ADDENDUM NO. 2

HELENA FIRE STATION #3

PROJECT: Helena Fire Station #3
Helena, Montana

ARCHITECT: DOWLING Architects
734 North Last Chance Gulch
Helena, MT 59601
406-457-5470

18 116 SCBA ELEVATION 1
A7-5 1/4" = 1'-0"

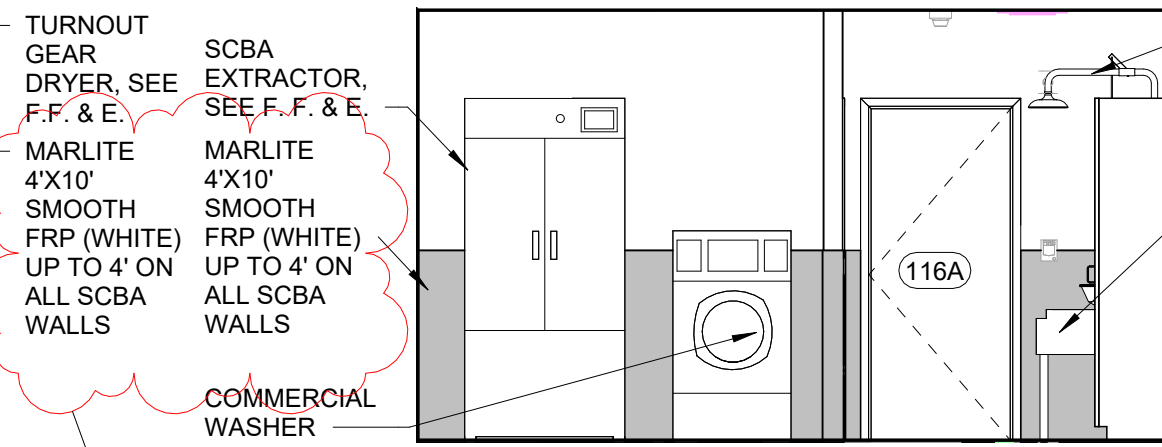
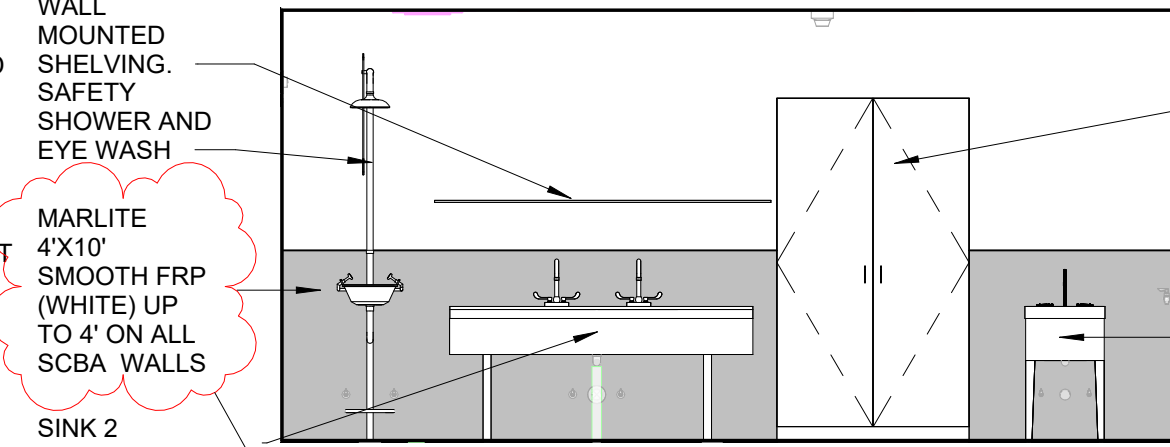
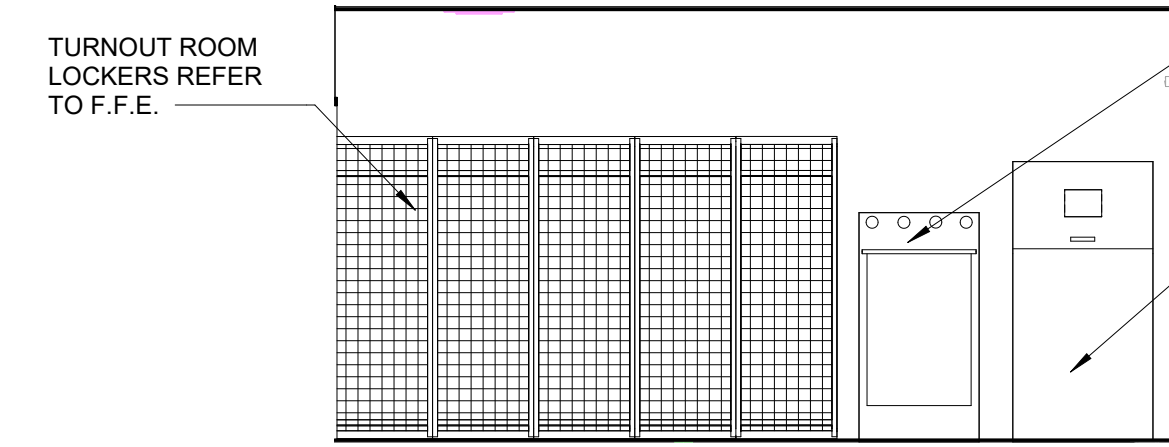
11. **Question:** Sheet A3-3 calls out FRP for the SCBA rooms. No FRP is included in the specifications? Please provide FRP Specifications.

Answer: No new specification section will be issued for FRP. However, the notes regarding FRP on sheet A7-3 & A has been revised as follows: MARLITE 4'X10' SMOOTH FRP (WHITE) UP TO 4' ON ALL SCBA WALLS

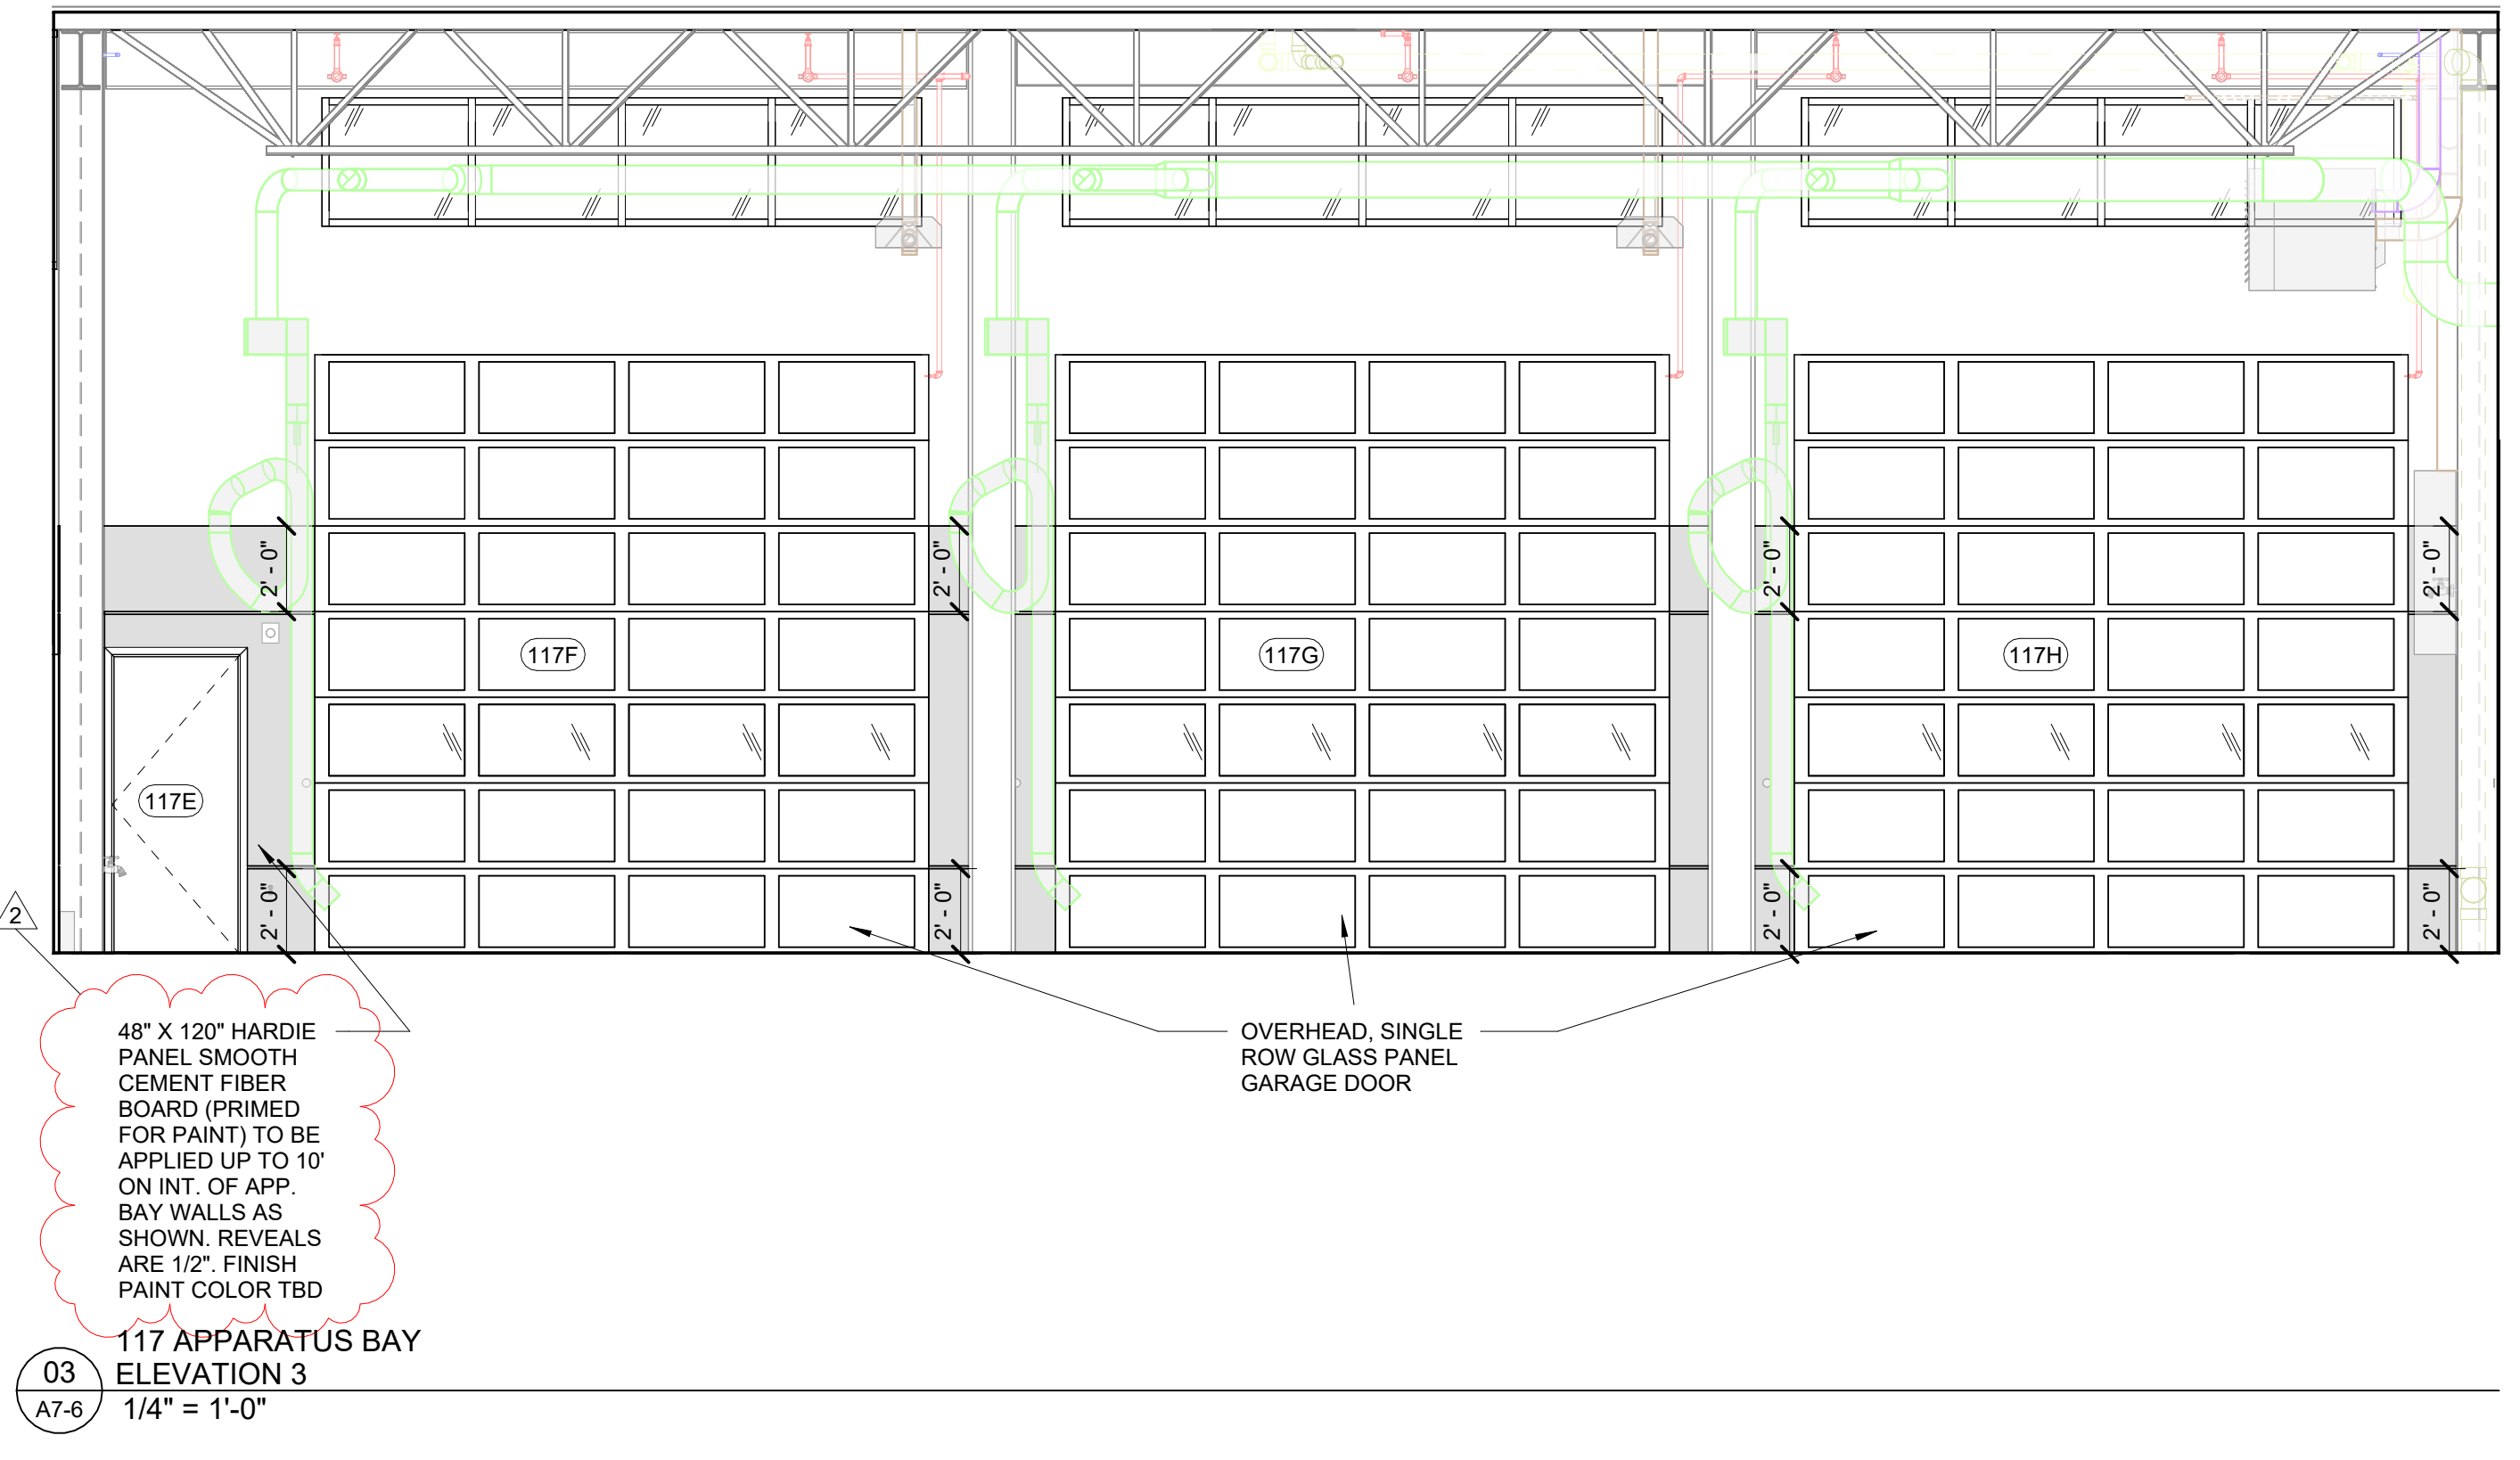
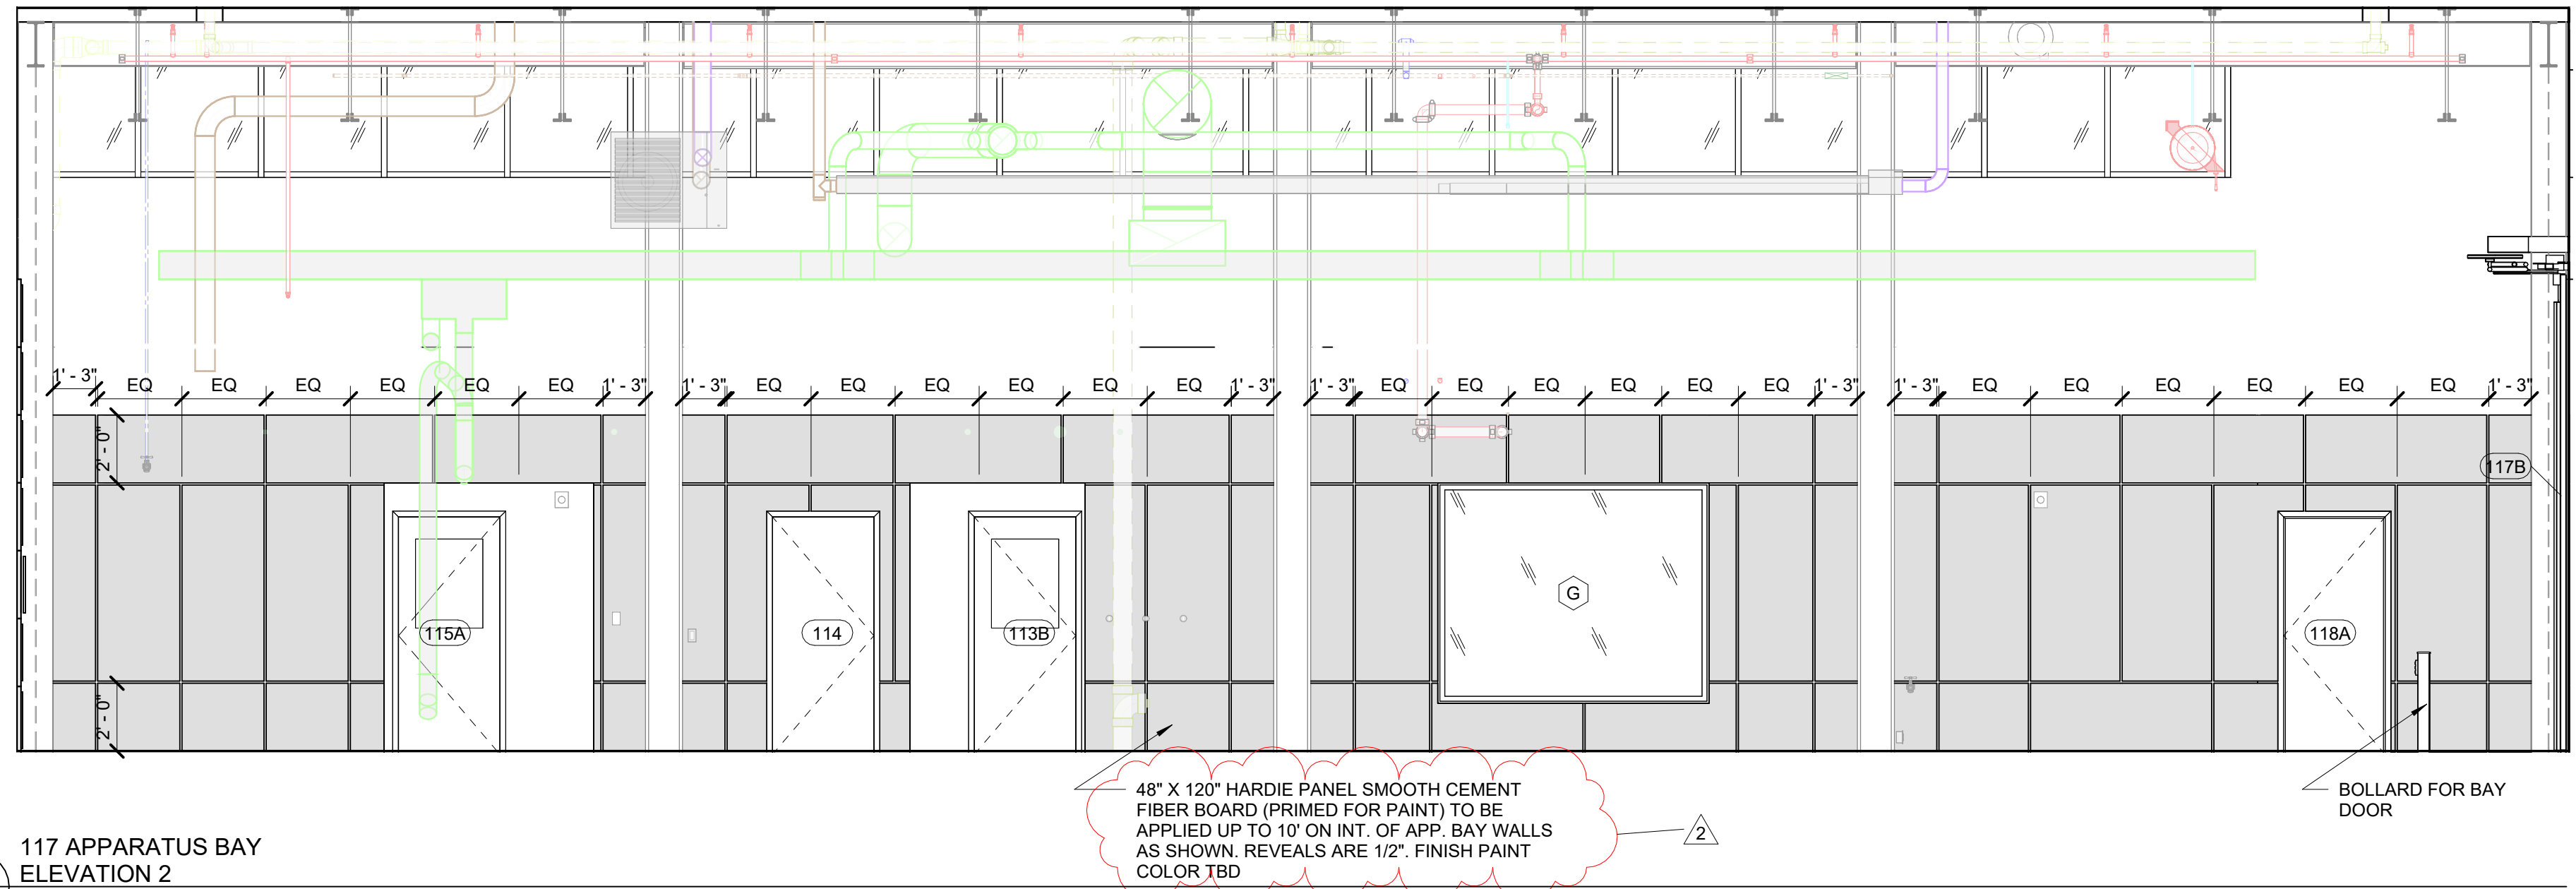
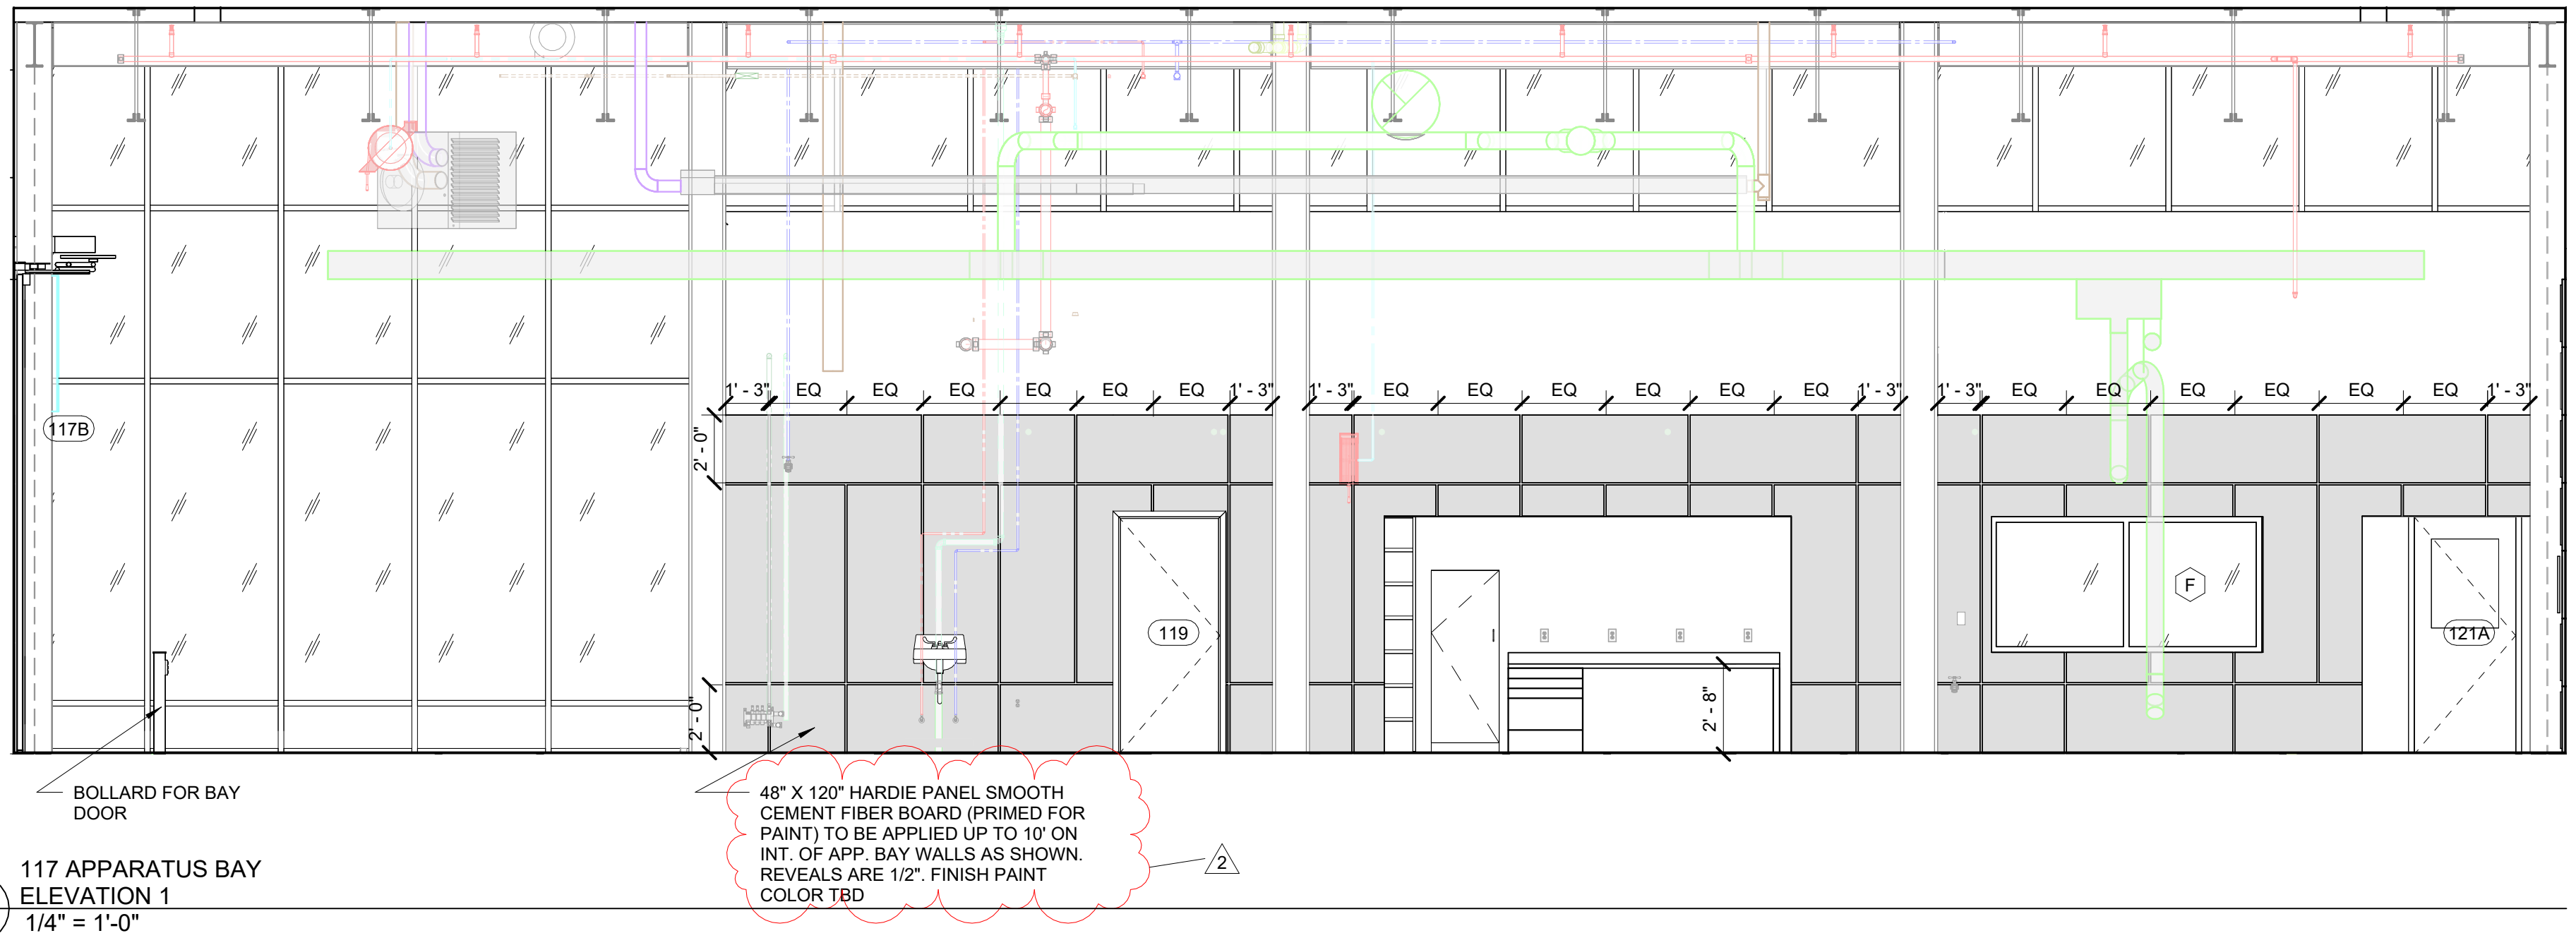
10. **Question:** Sheet A1-2 and sheet A7-6 indicate 'Cement Fiber Panels' in Apparatus Bay. Please provide a specification for the cement fiber panels.

- **Sheet A 7-6- Interior Elevations:** Revised note regarding Cement Fiber Board to more directly specify product.
- **Sheet A7-7 Casework-** Added casework detail for bathroom 124&125 to show the sink & counter top condition, as well as added typical taller casework drawings (cabinets/dorm lockers)

Answer: No new specification section will be issued for Cement Fiber Panels, however the notes regarding cement fiber panel on sheet A7-6 has been revised as follows: 48" X 120" HARDIE PANEL SMOOTH CEMENT FIBER BOARD (PRIMED FOR PAINT) TO BE APPLIED UP TO 10' ON INT. OF APP. BAY WALLS AS SHOWN. REVEALS ARE 1/2". FINISH PAINT COLOR TBD
